BUREAU OF
ENGINEERING

Subject: Venice Dual Force Main (CF 08-0504) Environmental Impact Report

We transmit herewith additional information to clarify and amplify the information previously provided about the proposed Venice Dual Force Main, and we urge the City Council to move forward with certification of the Venice Dual Force Main Environmental Impact Report (EIR) and related actions as recommended in the report from the Public Works Committee dated December 4, 2008.

Figure 1

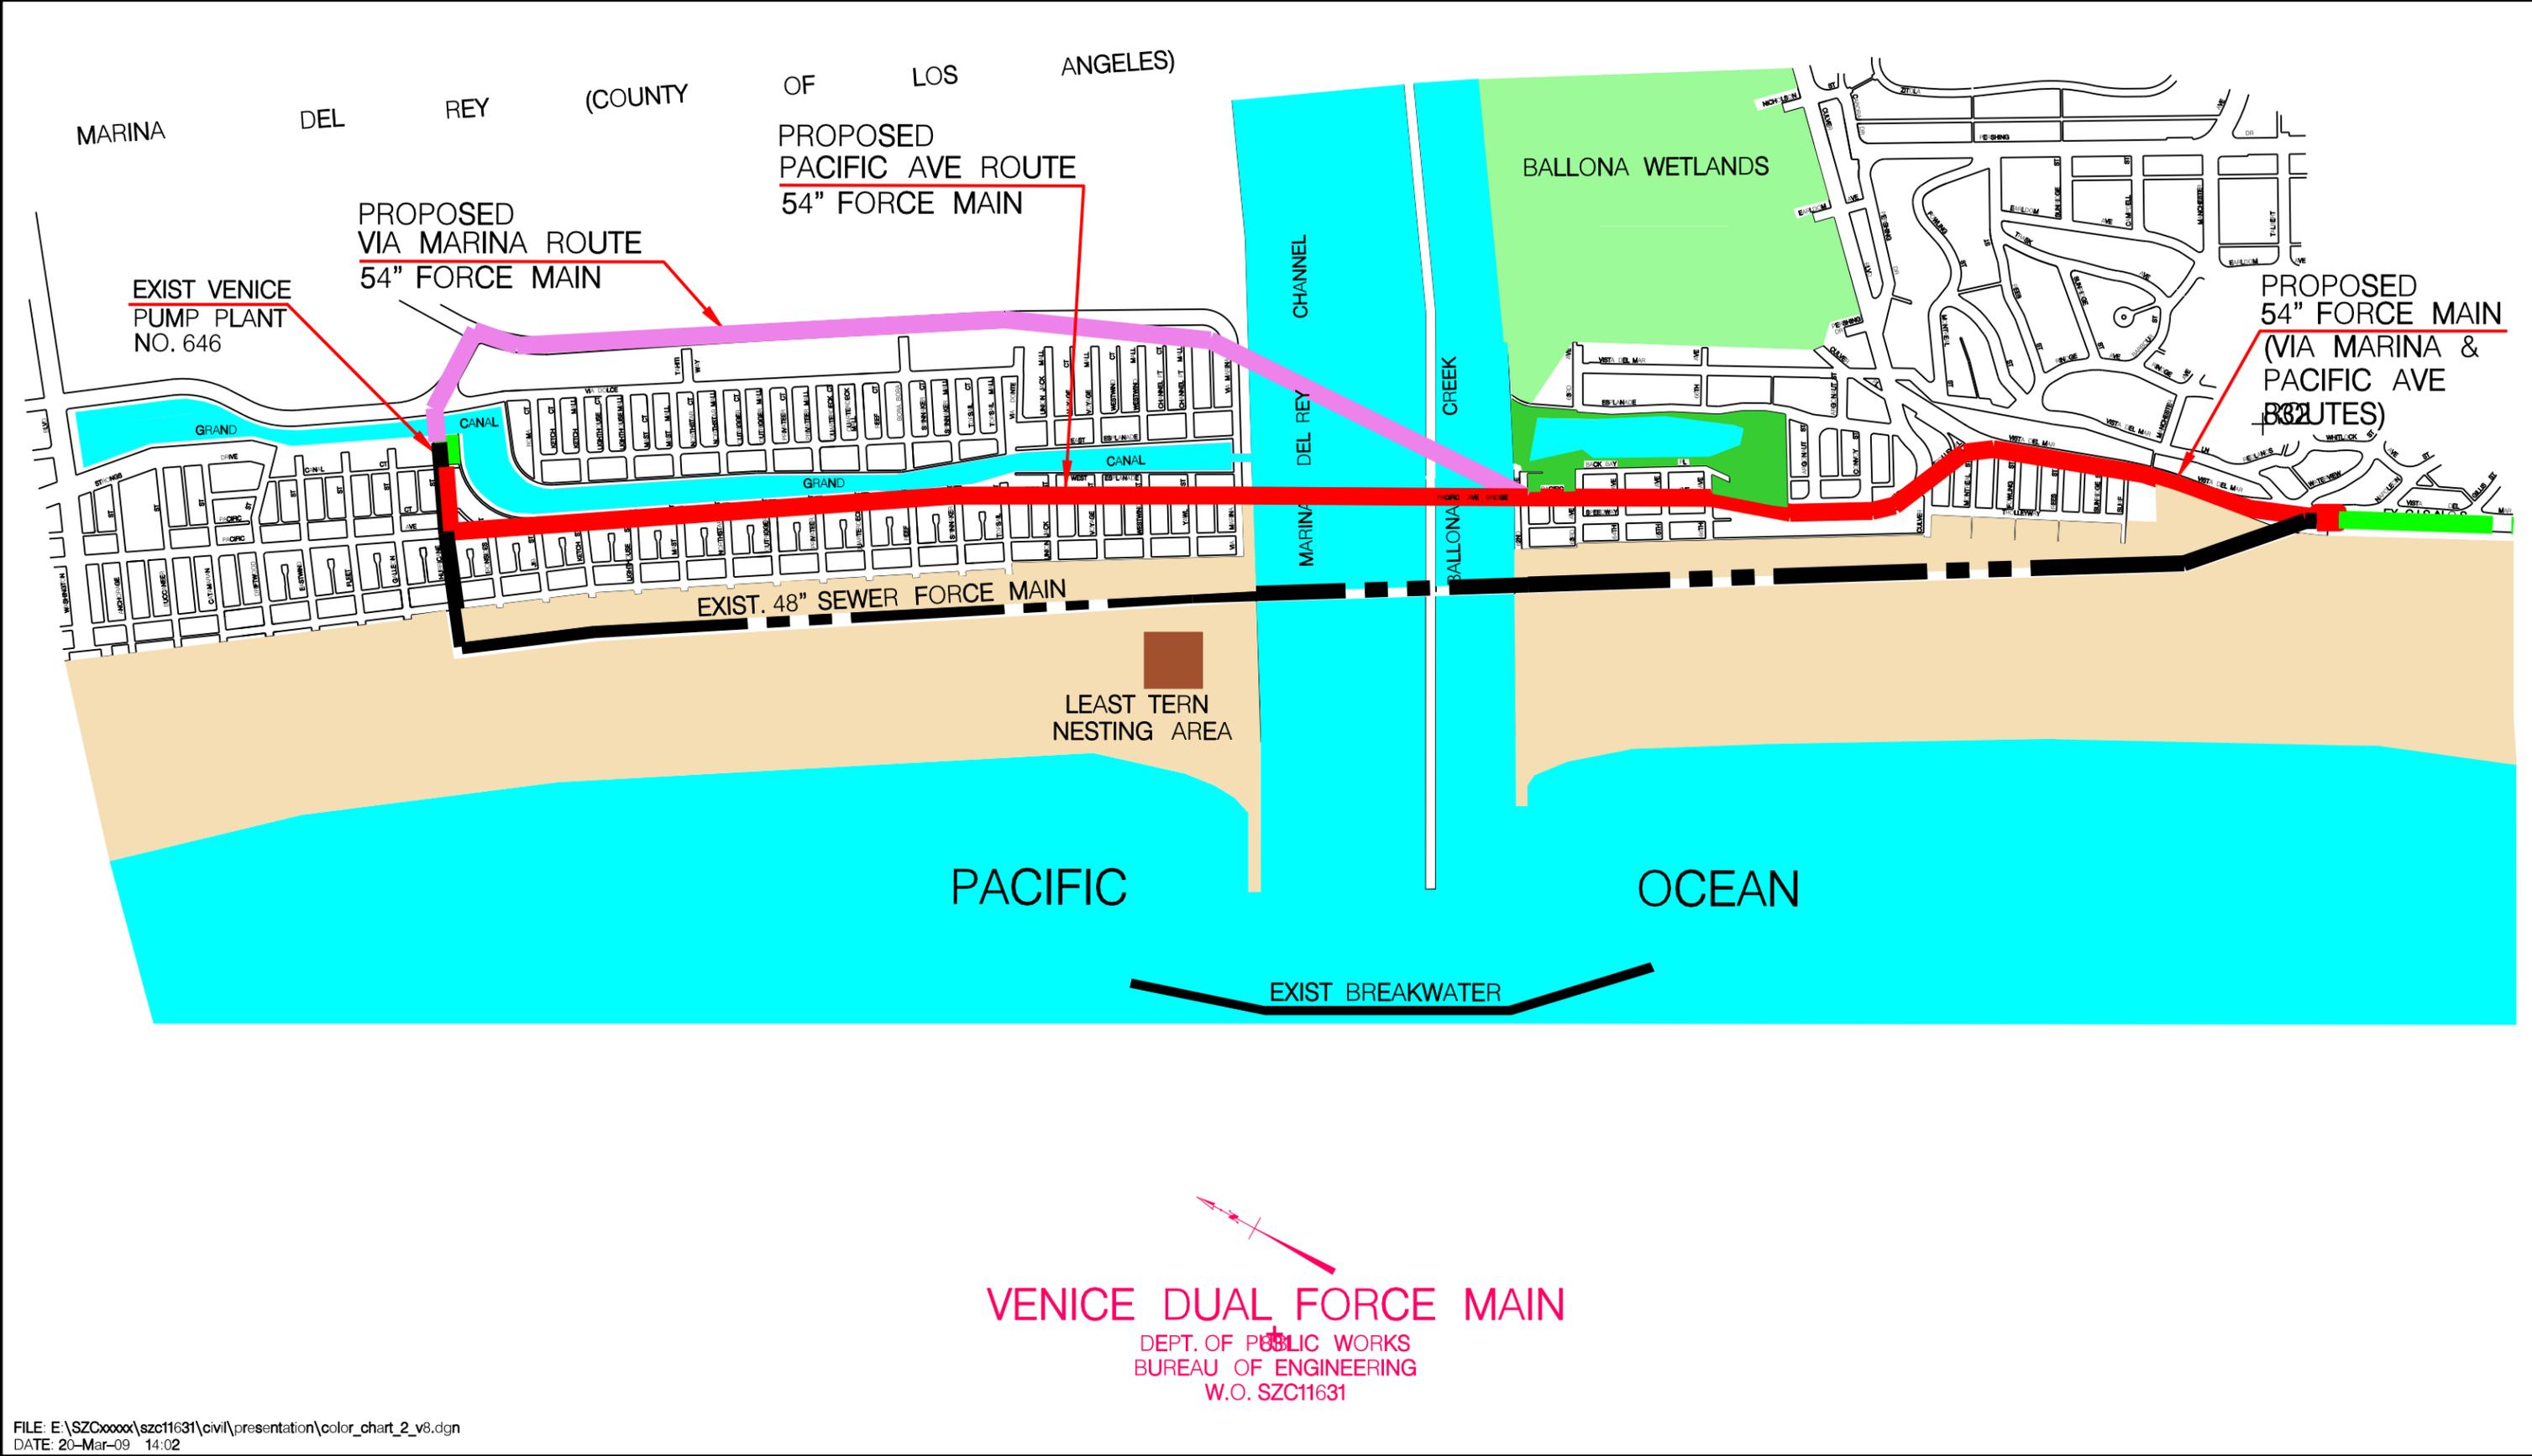
Two alignments, one on Via Marina and one on Pacific Avenue, have been considered for the portion of this project north of the Marina del Rey Channel as shown on Figure 1. As for the portion south of the channel, Pacific Avenue offers the only viable route outside of the beach. The dimensions considered for the shafts and work areas are consistent for both routes. However, this and the next section discuss in detail the Pacific Avenue route as Pacific Avenue is the narrower of the two streets and as such, the impacts of a micro-tunneling operation of this size will be more significant on Pacific when compared to Via Marina.

The Pacific Avenue alignment would begin at the Venice Pump Plant on Hurricane Street and travel westerly along Hurricane Street, southerly along Pacific Avenue, southerly under Marina del Rey Channel and Ballona Creek (the channel), continuing southerly along Pacific to the existing Coastal Interceptor Sewer (CIS) junction structure on Vista Del Mar near Waterview Street.
